**Soil and
Water Management Plan**

Williamtown Sand Syndicate Pty Ltd

Williamtown Sand
Cabbage Tree Road, Williamtown

7 July 2021

Figure 7: Water monitoring locations and elevation across the Subject Land and surrounds

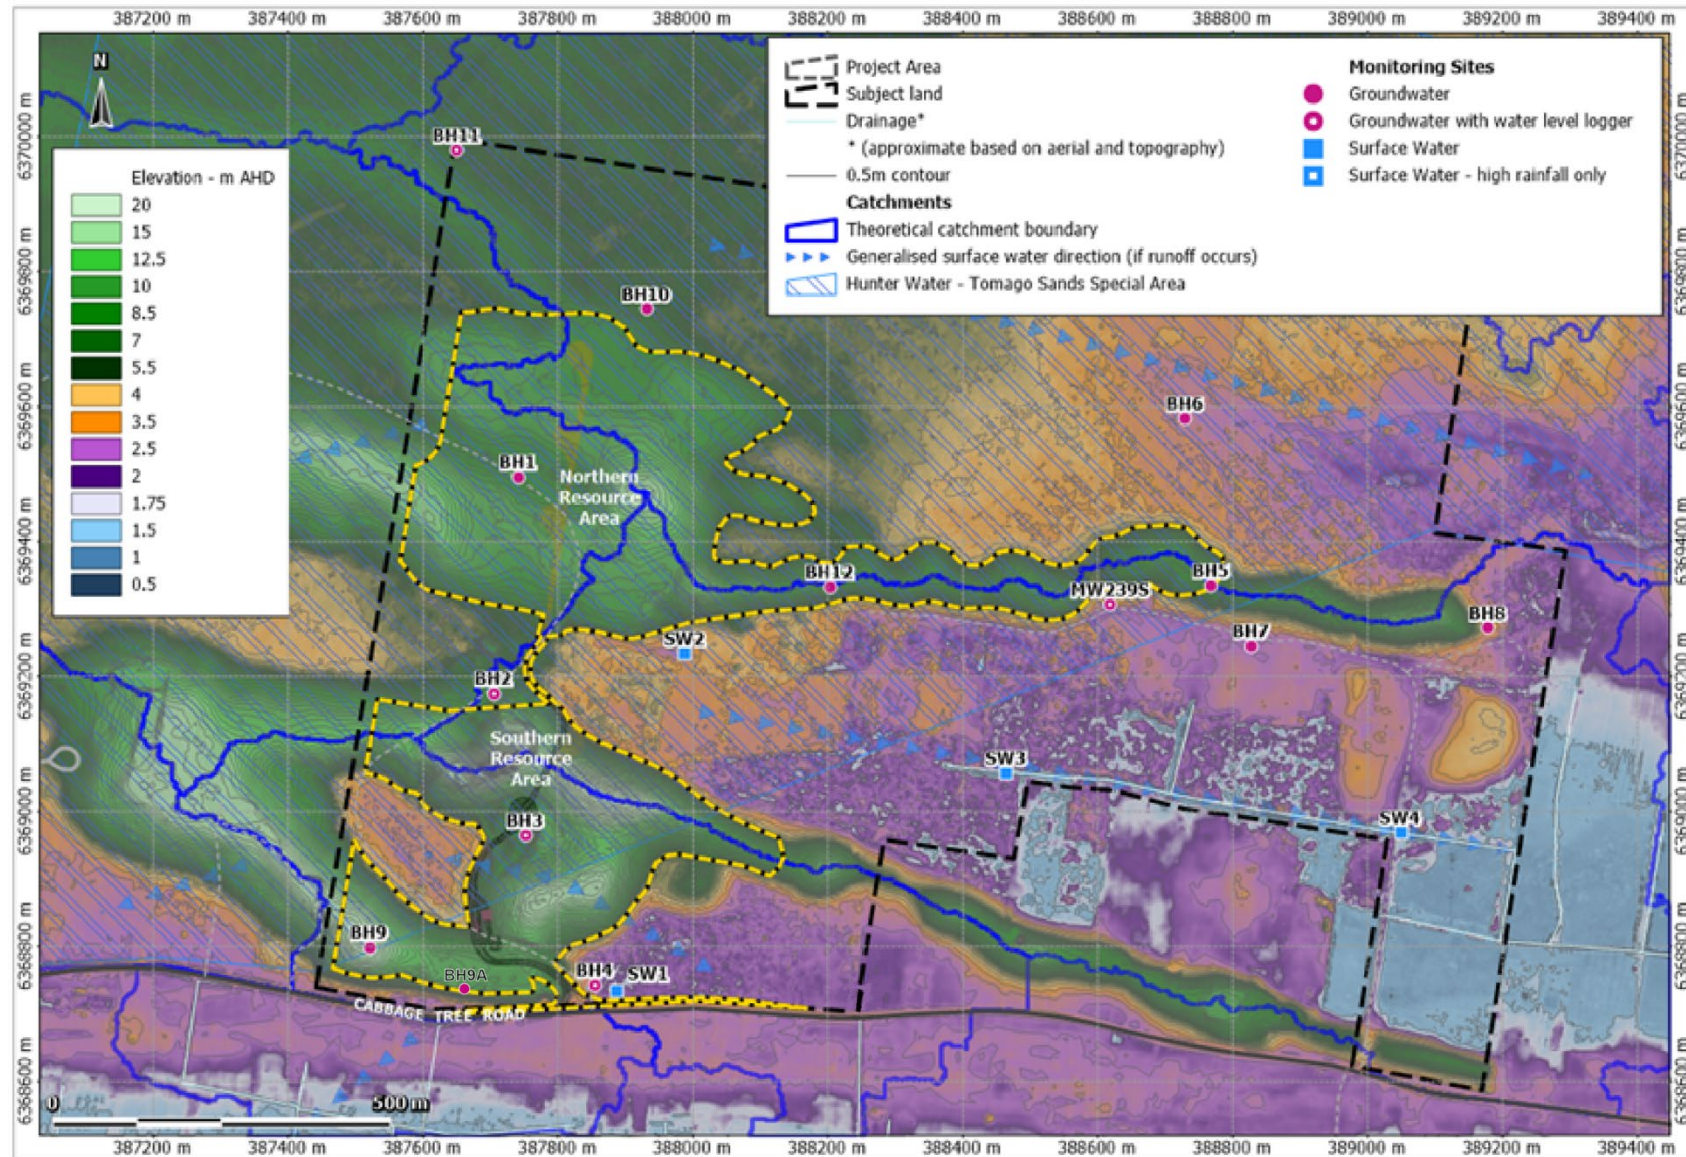
Table 17 does not include monitoring site SW5. Revised SWMP comment provided: “SW5 has been removed from monitoring due to the distance from site, upgradient screening provided by SW4, rarity of flow, absence of baseline and difficulty in safely sampling the site, and the dominance in the water		The Department notes that SW1 (not SW4) serves as a suitable monitoring location to evaluate any potential impacts to the receiving environment from the quarry operations. On this basis, the Department accepts the removal of SW5. Considered adequate. Please remove SW5 from Figure 7.

Figure 8: (Appendix 3) Screenshot of the Umwelt groundwater model in Groundwater Vistas

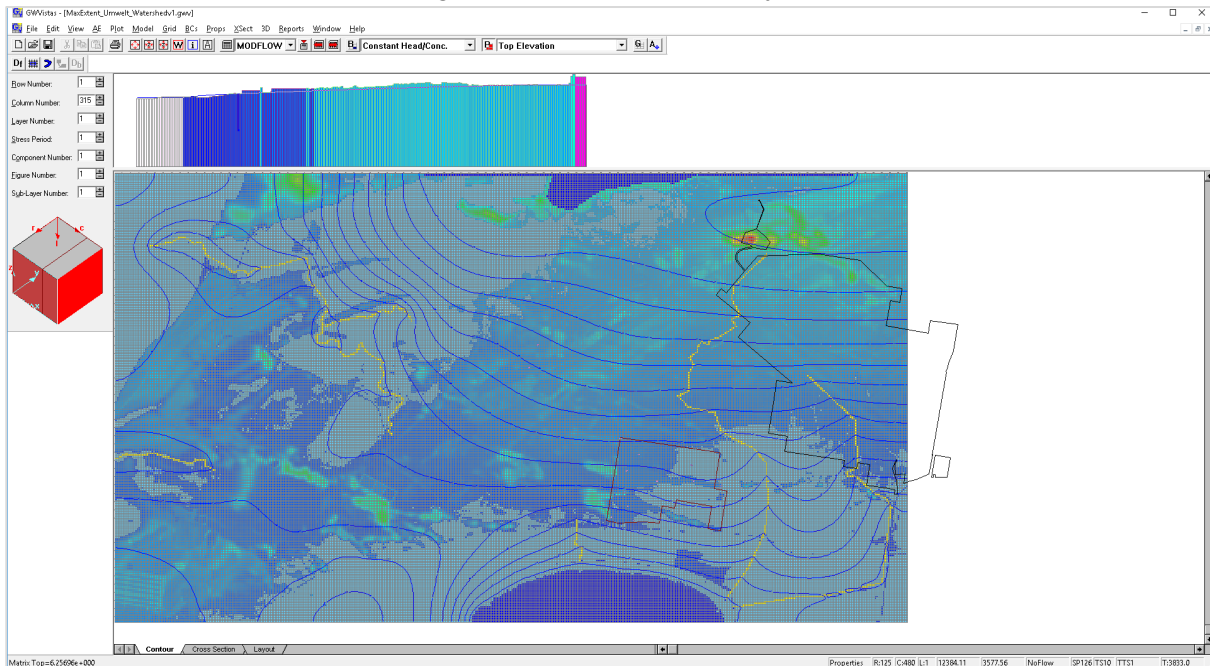
- Constant head at Fullerton Cove, set to 0.6 mAHD, which is appropriate (Figure 7).
- Constant head at Grahamstown Dam, set to 7.75 mAHD. The level itself is reasonable, but in reality, this waterbody does not interact with the groundwater in the Tomago Sandbeds due to the clay liner installed along the southern wall/bank of the reservoir.
- Recharge and evapotranspiration are estimated as % of rainfall and potential evaporation (PE). As stated in Umwelt (2015), recharge is set to 35% of rainfall, while evapotranspiration from the water table is set to a maximum rate of 60% of PE. Extinction depth for evapotranspiration has been set at a base level of 2.5 m, and lower value of 1 m also considered. These are appropriate for the area around the quarry.

- Watercourses are represented using MODFLOW 'Drain' package (yellow lines on Figure 7), which accounts for baseflow, but not leakage.
- The model does not incorporate pumping from the HWC borefields. As noted by Umwelt, this makes the predictions more conservative with respect to high groundwater levels, so is appropriate.
